STAFF REPORT
COMMUNITY DEVELOPMENT DEPARTMENT

HEARING DATE: 4/1/2021
 TO: Planning & Zoning Commission
 FROM: Alan Tiefenbach, Associate Planner
 208-884-5533
 Bruce Freckleton, Development Services Manager
 208-887-2211
 SUBJECT: AZ H-2021-0008
 Meridian South Fire Station & Police Substation
 LOCATION: 2385 E. Lake Hazel Rd
 South side of E. Lake Hazel Rd, between S. Locust Grove Rd. and S. Eagle Rd.

A. Concept Plan (date: 1/5/2021)

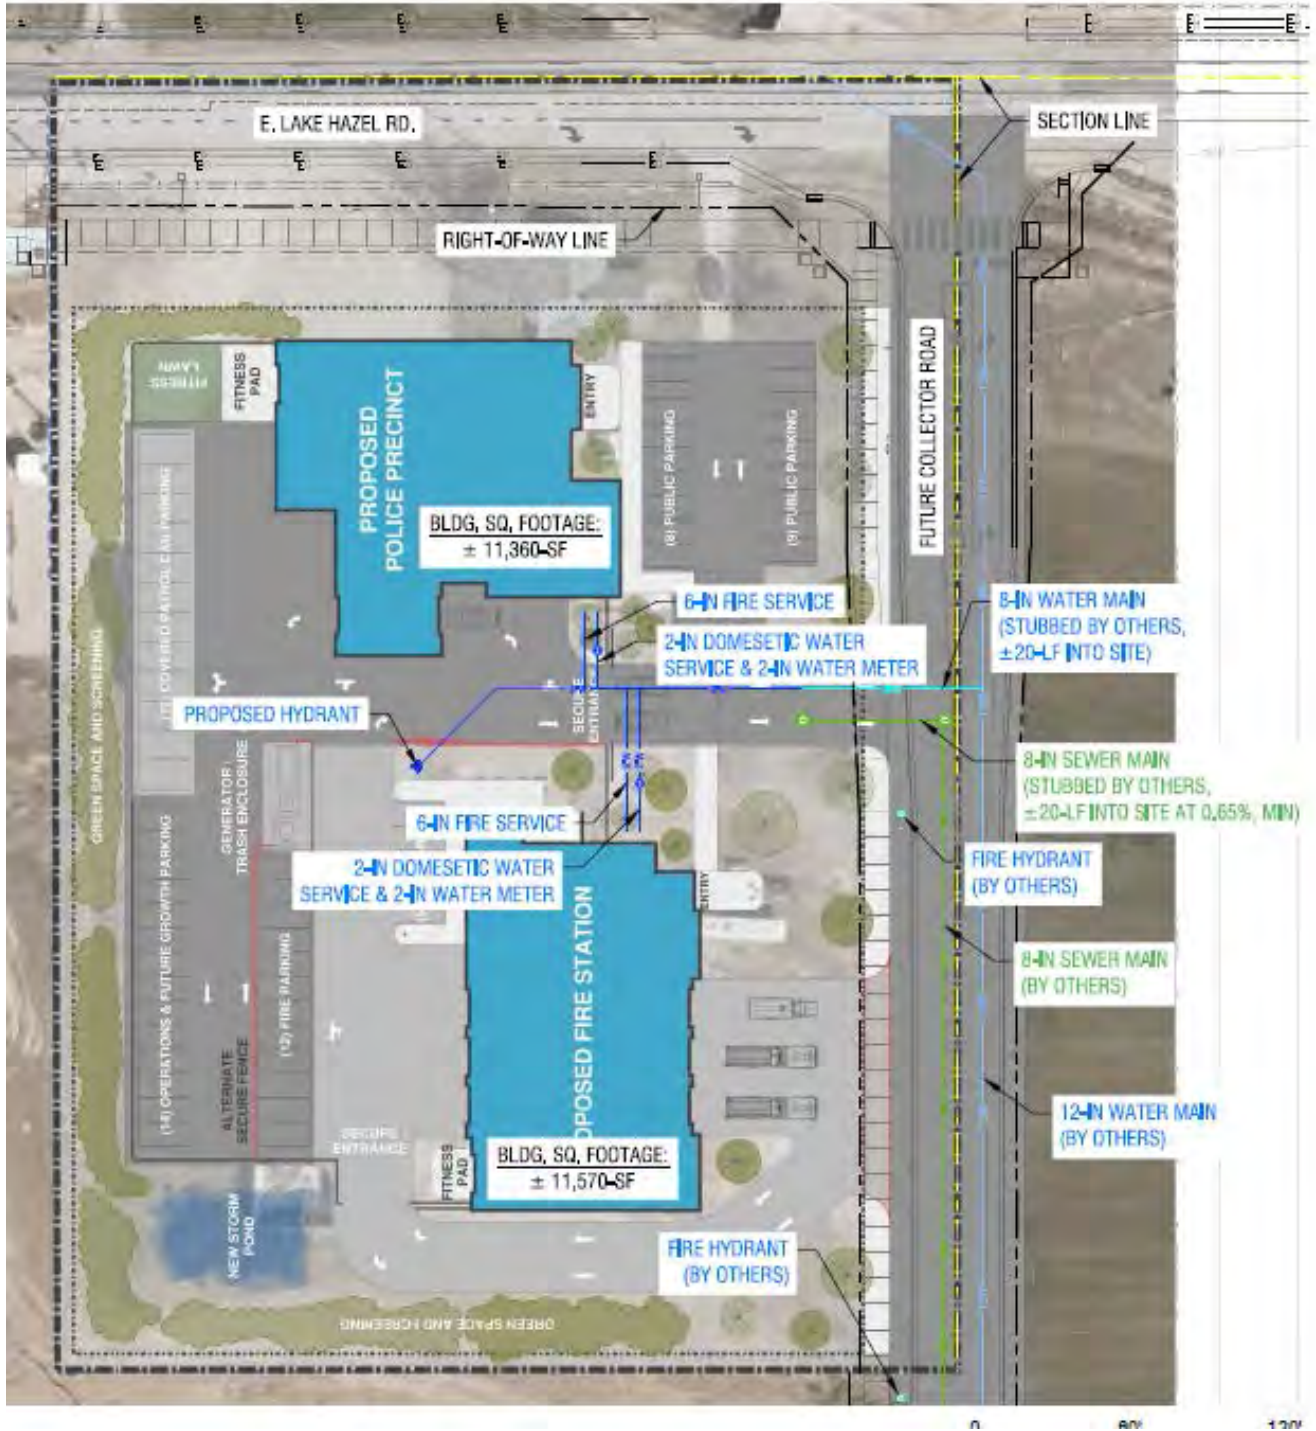
The applicant's concept plan shows landscape buffers along E. Lake Rd and the future collector street. Landscape screening is reflected on the plan to screen the site from Discovery Park at the west and any future development to the south.

The parking plan does not appear to meet all the landscaping requirements of UDC 11-3B-8. Internal parking lot landscaping is required with any parking lot with more than 12 spaces, including internal islands at intervals no greater than 12 spaces. Landscape planters are also required at the end of rows of parking. This will need to be addressed at the time of CZC submittal.

The submitted concept plan does suggest the road buffers are incorporated but along the E. Lake Hazel Rd frontage there is no landscaping shown. As mentioned in the parking analysis above, the parking lot and road buffers will need to meet the requirements of UDC 11-2A-5 at the time of CZC.

The applicant proposes security fencing of up to 8' in height (fencing shown in red on the attached concept plan). The materials and type of fencing is not specified. Staff notes fencing height is limited to 6' in height in the R-8 zone district. The applicant should apply for alternative compliance concurrently with the CZC.

- g. Parking lot landscaping shall meet the requirements of UDC 11-3B-8C.
- h. At time of CZC, a landscape plan shall be submitted that preserves any existing trees on the subject property that are four-inch caliper or greater; or mitigate for the loss of such trees as set forth in UDC 11-3B-10C.

- i. Applicant shall comply with any ACHD conditions of approval.
- j. All proposed fencing and/or any fencing shall be constructed as required by the UDC, consistent with the standards as set forth in UDC 11-3A-7 and 11-3A-6B, as applicable, or submit an application for alternative compliance concurrent with the future CUP or CZC/DES application.

B. Water Main and Service Sizing Plan (date: 2/23/2021)

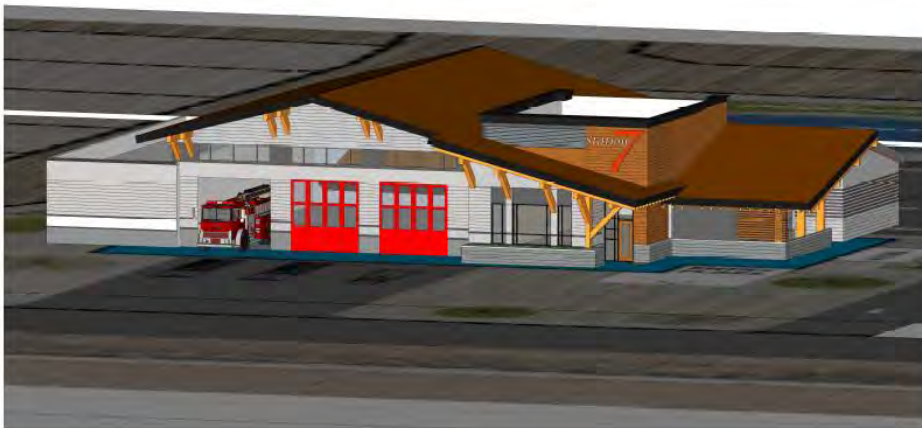
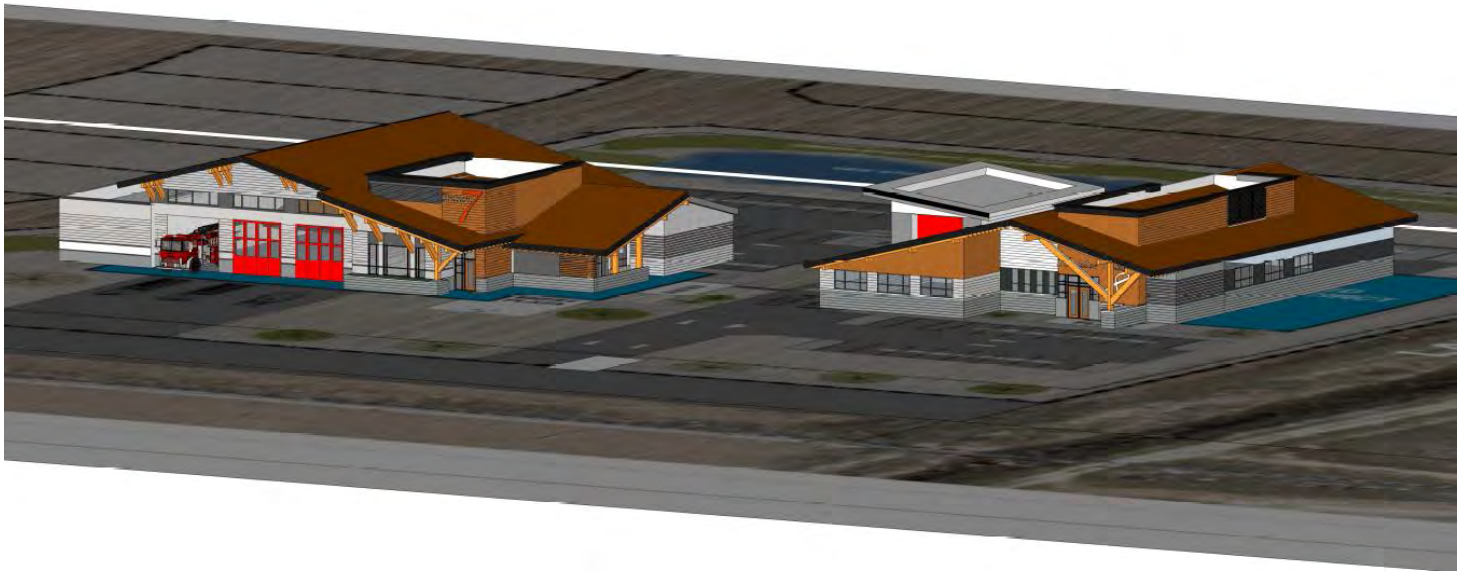
Connection to City water and sewer services is proposed in accord with UDC 11-3A-21. The submitted Water Main & Service Sizing Plan indicates 8" water and sewer lines serving the property. Water would be provided from a main in E. Lake Hazel Rd. Sewer would be provided from a main at Discovery Park.

- 2.1 Applicant shall coordinate water and sewer main size and routing with the Public Works Department. Minimum cover over sewer mains is three feet, if cover from top of pipe to sub-grade is less than three feet than alternate materials shall be used in conformance of City of Meridian Public Works Departments Standard Specifications.
